Public Service Company

September 14, 1979
Fort St. Vrain
Unit 1
P-79209

Subject: I & E Bulletin 79-02,
Base Plate Design Using
Concrete Expansion Anchor
Bolts

TYPICAL ANALYTICAL MODEL USED TO ANALYZE A FOUR HOLE
BASE PLATE FOR EXPANSION ANCHOR BOLT LOADS

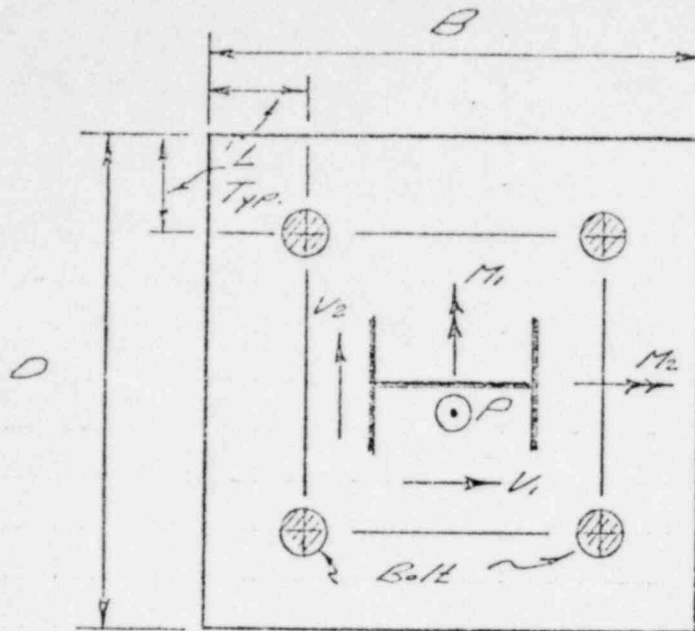
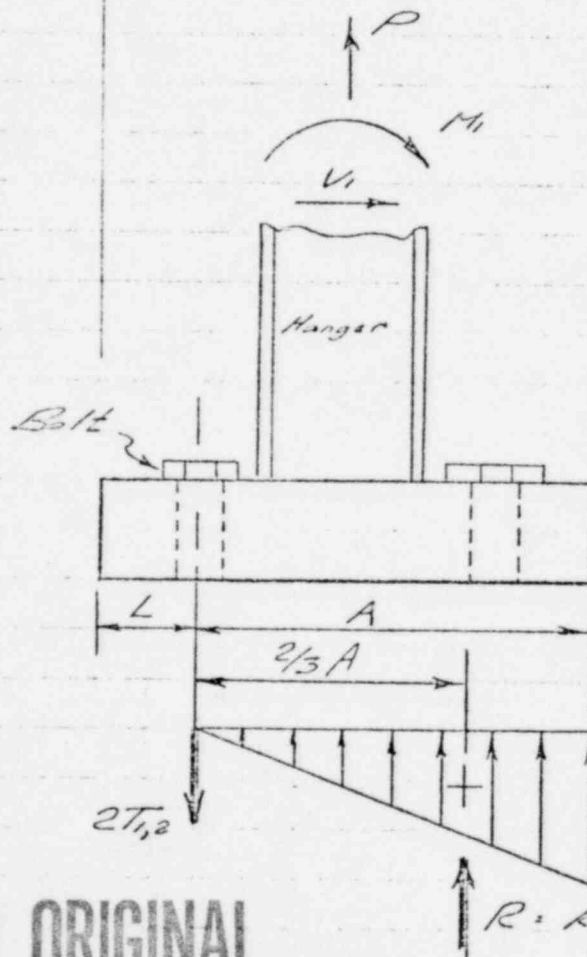
Question 2 Please supply information on the model used to analytically calculate the anchor bolt loads.

Answer: A typical model used to calculate the anchor bolt loads is outlined in Attachment 1.
